IEEE 802.3cg
Clause 148 cleanup
September 9th, 2019

- During the initial SA ballot phase there have been a number of comments asking for clarifications and fixing state diagram semantic. These were mainly related to:
 - Timers and tolerances
 - Clocks & timings definition
 - Execution order of state diagram statements
 - Operators precedence
- None of these comments was intended to change the functionality being described
 - But they introduced a few editorial and technical regressions
- Several individuals with different affiliations worked in background to stabilize the draft
- This presentation shows the final changes that have been checked and validated by all parties

#5 non-PLCA nodes preventing PLCA from starting (1)

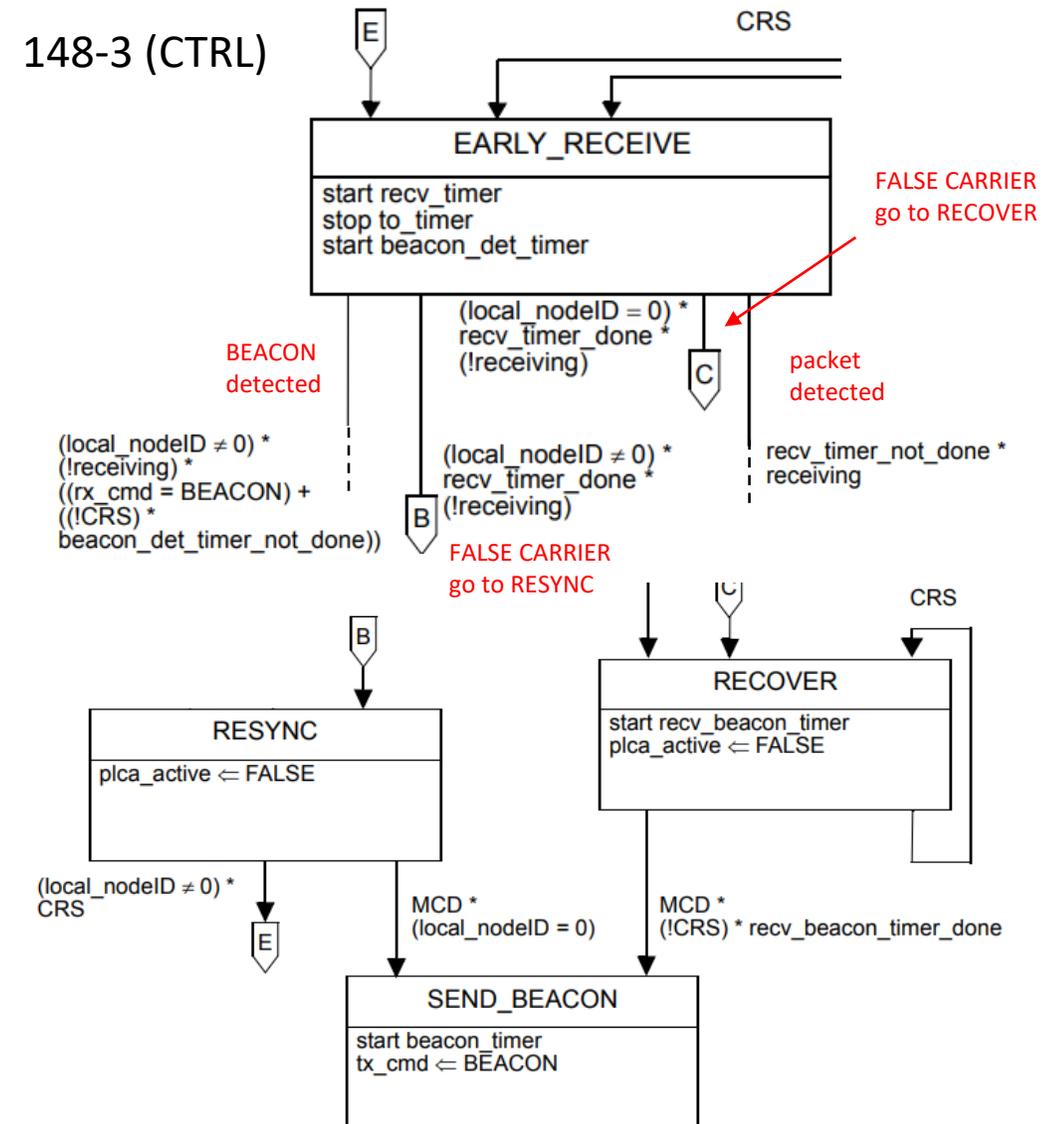
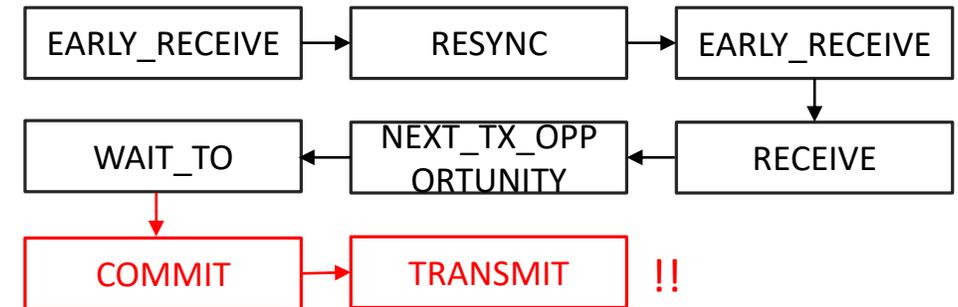
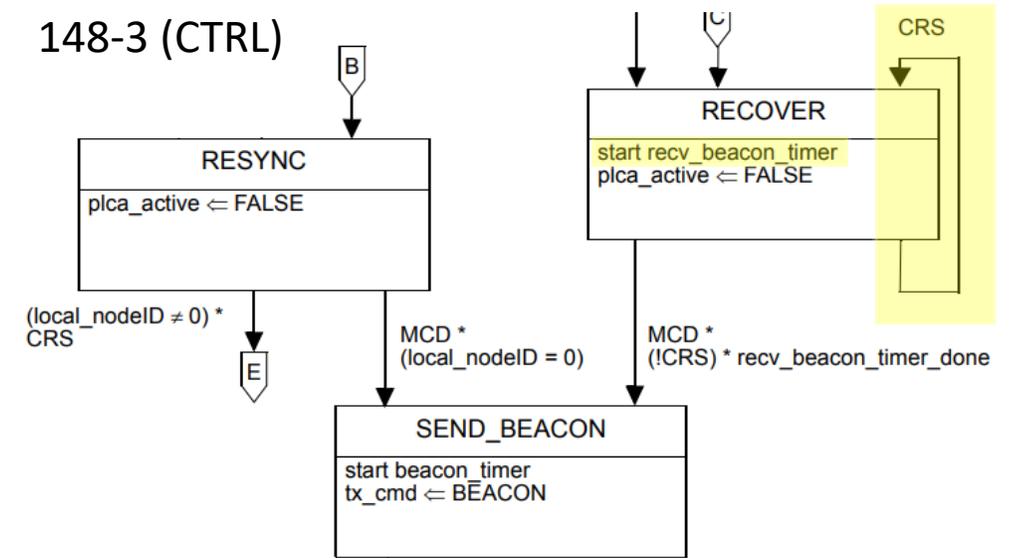
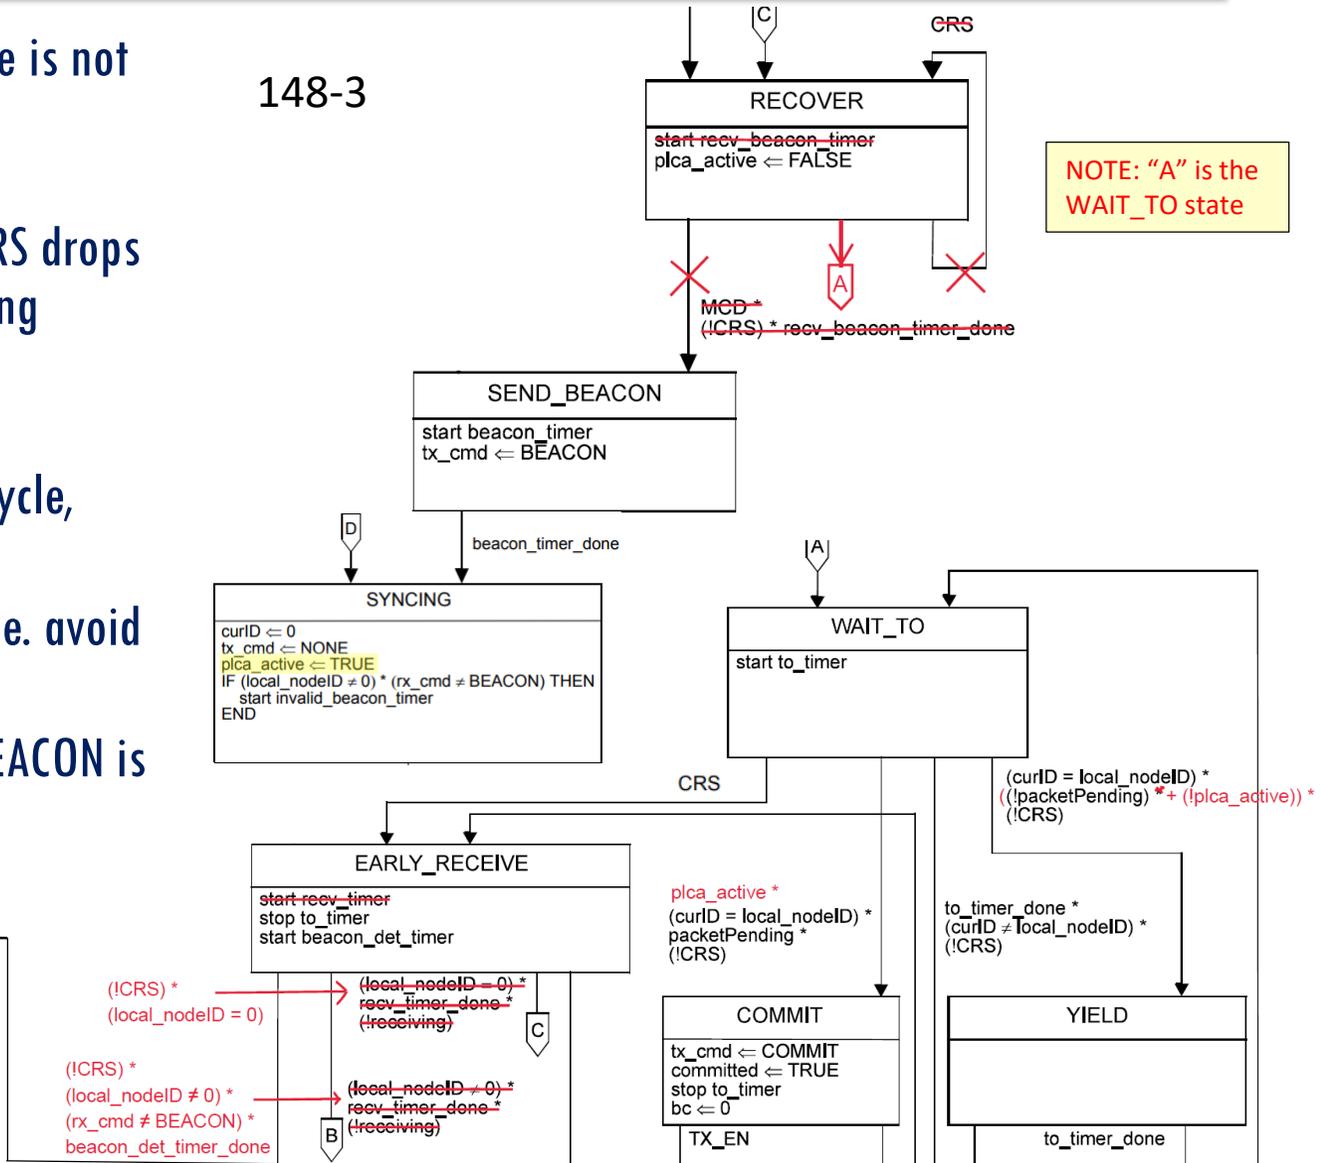
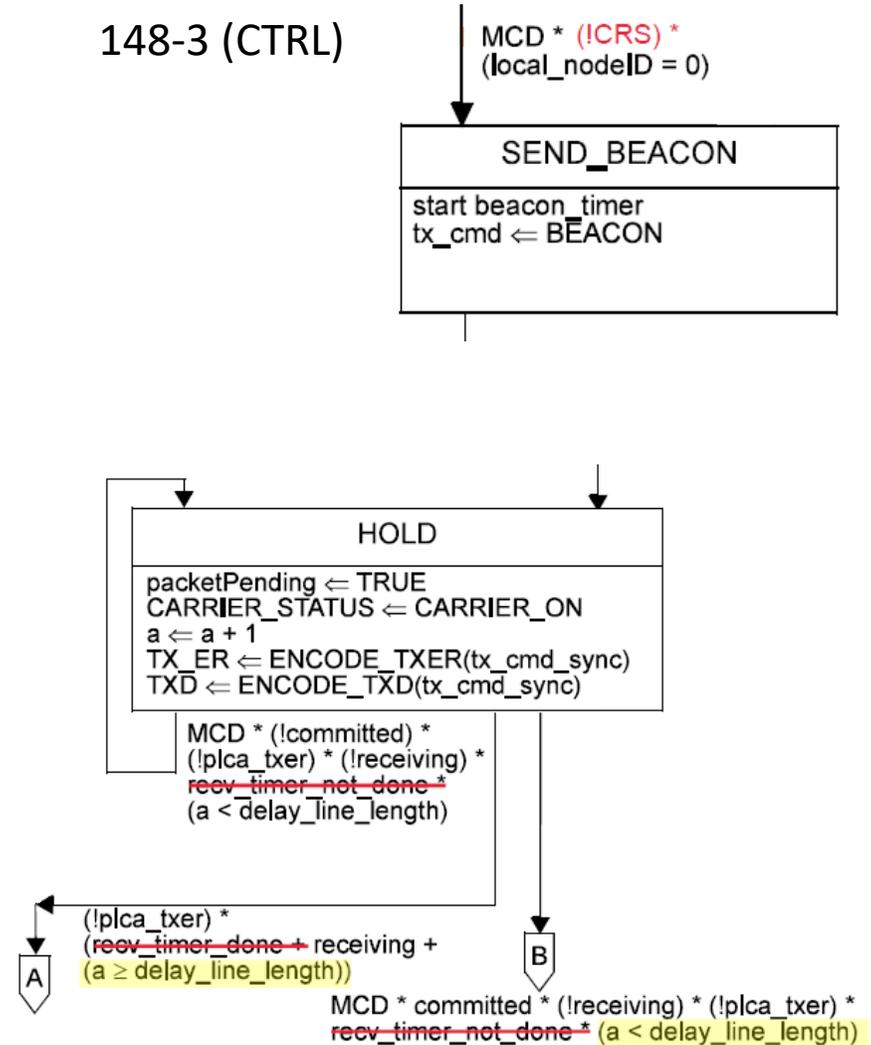
- PLCA features a “recovery” mechanism that makes a node skip its TO in case the internal TO counter is possibly misaligned.
 - This may happen when a false carrier event (e.g. impulsive noise) occurs on the line. In such situation each PHY on the network *may* assert CRS (which is involved in the counting of the TOs) for a different duration.

- This is captured by the PLCA CONTROL State Daigram by the means of the EARLY_RECEIVE, RESYNC and RECOVER states
- The idea is that when a CRS event is not followed by the reception of a packet within `recv_timer` duration (i.e. the PHY could not decode the data), the node goes either in RECOVER or RESYNC state depending on whether it is the one in charge for sending the BEACON (`local_nodeID = 0`) or not.

- In RESYNC state a node waits for a new BEACON before getting a new TO
 - In RECOVER state (`local_nodeID = 0`) the node waits for the line to be quiet (`CRS = FALSE`) for a certain amount of time before sending a new BEACON

- In the **very unlikely** case where non-PLCA enabled nodes are sending packets at a rate which is higher than the `recv_beacon_timer` frequency, the node in charge of sending the BEACON **may never reach the SEND_BEACON state**.
- Additionally, the BEACON may be sent when CRS is asserted, resulting in a collision on the line (performance loss)
- Finally, a node detecting a false carrier (`recv_timer` expired) *may* receive a packet (go to RECEIVE state) and get a new TO even if a *new* BEACON has not been received first (i.e. `curlD` may be out of sync).
 - This may create a collision (perf. loss)
 - It may also create a false BEACON detection (perf. loss)

The solution that easily solves all of these issues at once is not relying on the `recv_beacon_timer` and `recv_timer`.

- From `EARLY_RECEIVE` go to `RECOVER/RESYNC` when `CRS` drops and there is no `BEACON` indication and no packet being conveyed by the PHY.
- Allow from `RESYNC` and `RECOVER` states to go to `EARLY_RECEIVE/WAIT_TO` states as in normal PLCA cycle, having `plca_active = FALSE`
- Use `plca_active = FALSE` condition to yield the `TO` (i.e. avoid sending when `curID` may be out of sync).
- Eventually `plca_active` is set back to `TRUE` when a `BEACON` is received (`SYNCING` state)

Furthermore, wait for CRS to be de-asserted (line free) before sending the BEACON. This decreases significantly the chance to create a collision with a BEACON

Finally, the `recv_timer` was used in early drafts by the DATA State Diagram to exit the HOLD state during a RECOVERY. But this is already accomplished by the check against the `delay_line_length`. Therefore is safe to just remove this checks and remove the timer from the draft.

Fixes to Fig. 148-3 (PLCA Control State Diagram)

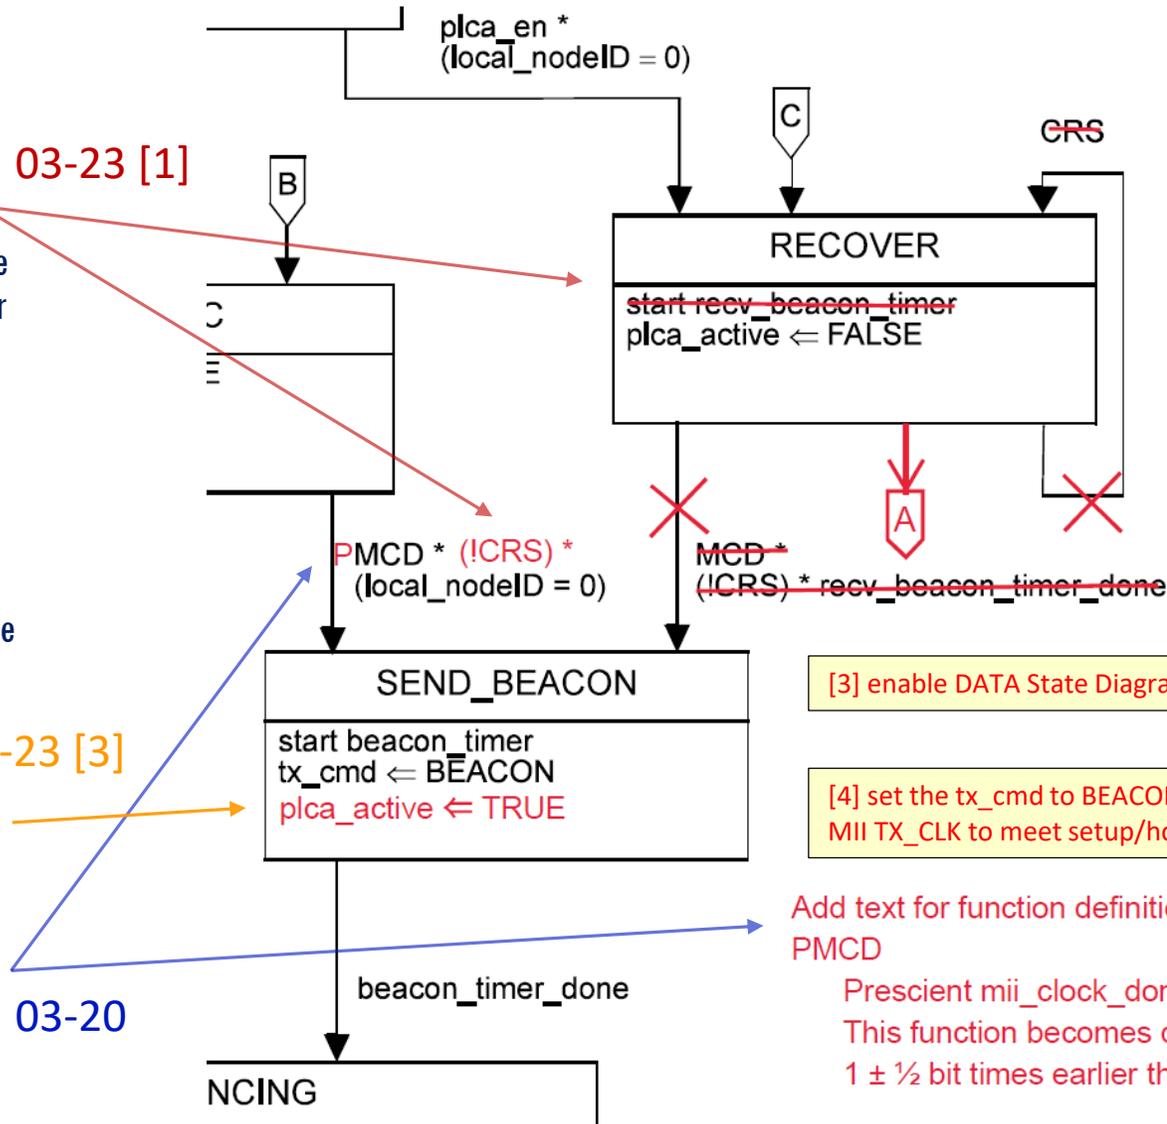
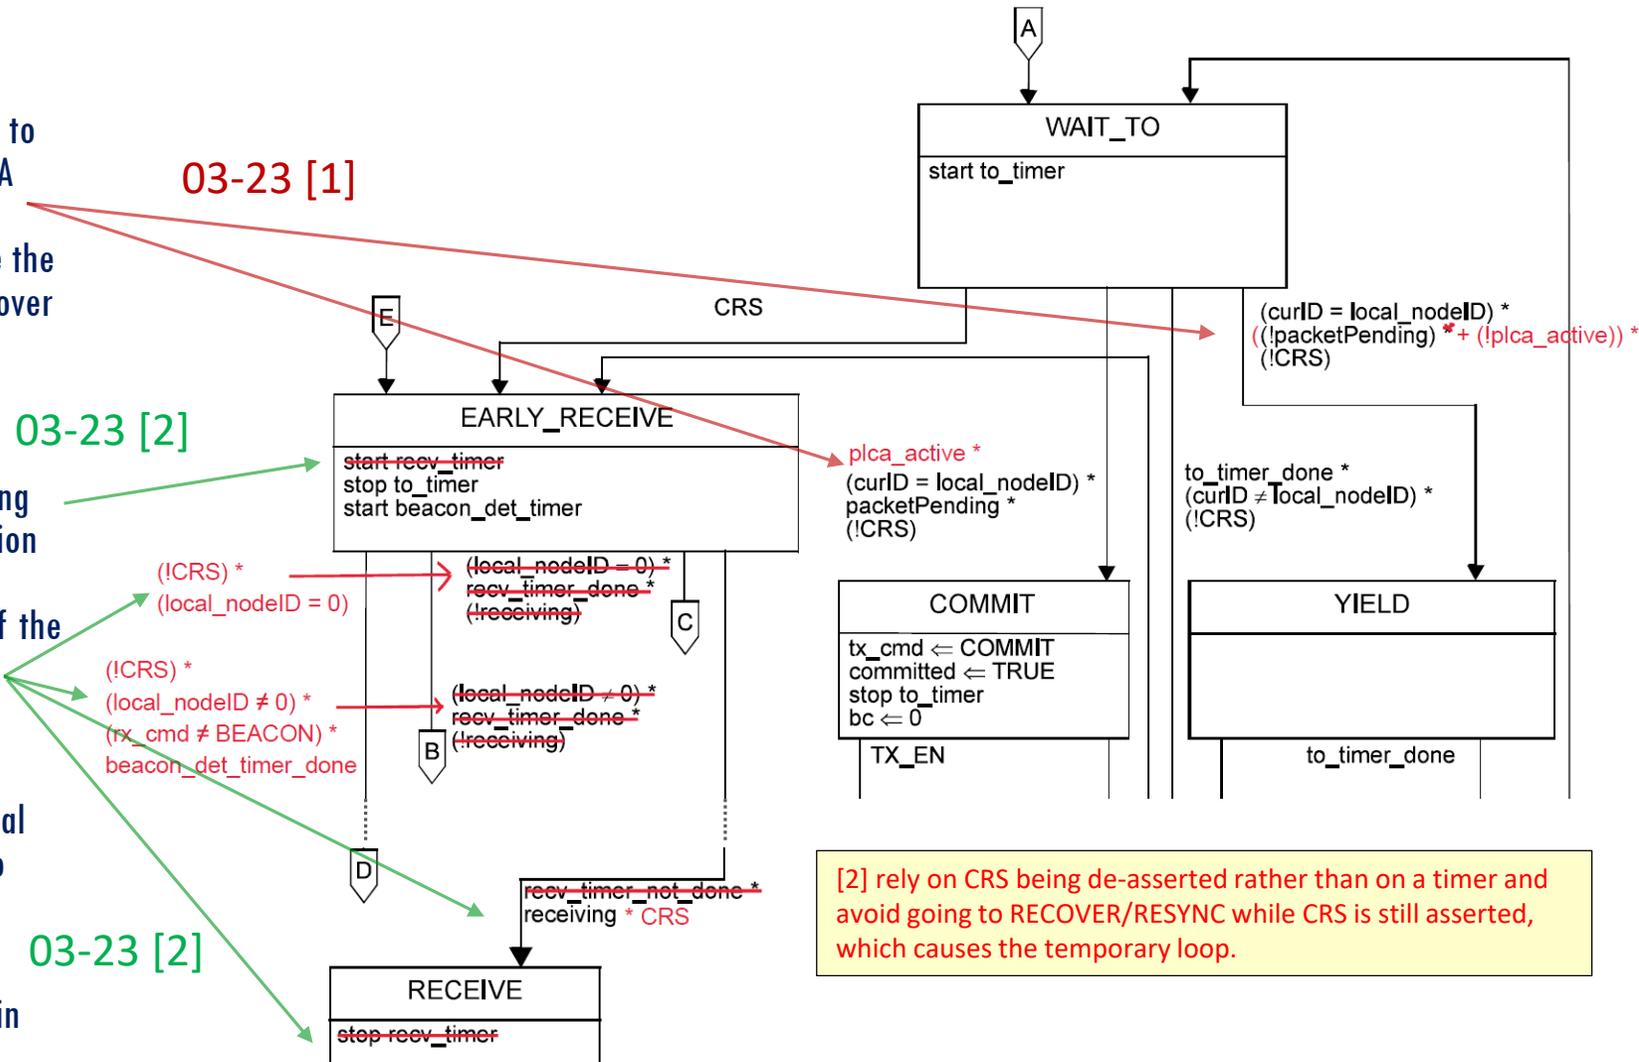
[1] The node with local_nodeID = 0 may not be able to send a BEACON in the unlikely situation that non-PLCA enabled nodes keep sending packets at a rate higher than the rcv_beacon_timer expiration. In such case the PLCA Control State diagram would be stuck in the recover state.

[2] The Control state diagram may loop from EARLY_RECEIVE and RESYNC state because of CRS being continuously asserted. This may cause a false detection of the BEACON if the rcv_timer elapses when CRS=TRUE at the end of a packet where the length of the CRS is compatible with the length of a BEACON.

[3] The BEACON may not be sent when PLCA is first enabled due to the Data state diagram being in normal state with plca_status = FAIL, preventing this one to become OK.

[4] Achieve proper synchronization with MII TX_CLK in the PLCA Data State Diagram

[1] The idea is that node with ID = 0 goes through a cycle of TOs with plca_active = FALSE before sending a BEACON. This prevents it from sending data during this cycle and allows other nodes to complete the previous cycle undisturbed. The CRS is further tested before sending the BEACON to reduce the chance of collisions in presence of non-PLCA enabled nodes.

[3] enable DATA State Diagram when BEACON is being sent

[4] set the tx_cmd to BEACON just before the posedge of the MII TX_CLK to meet setup/hold requirement.

Add text for function definition:
PMCD
Prescient mii_clock_done function.
This function becomes done exactly $1 \pm \frac{1}{2}$ bit times earlier than mii_clock_done
